November 29, 2021

Subject: #2005-B Elections Building Remodel – Addendum #1

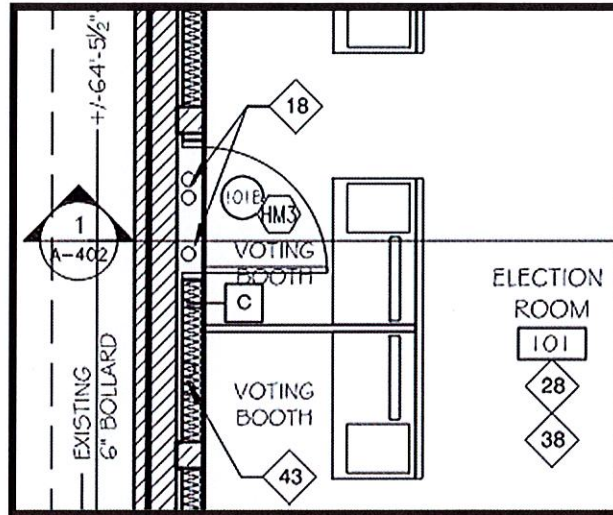
27. Bid Form: Bid form spreadsheet needs Plumbing division.

- a. Plumbing is in division 15, see section 015300.
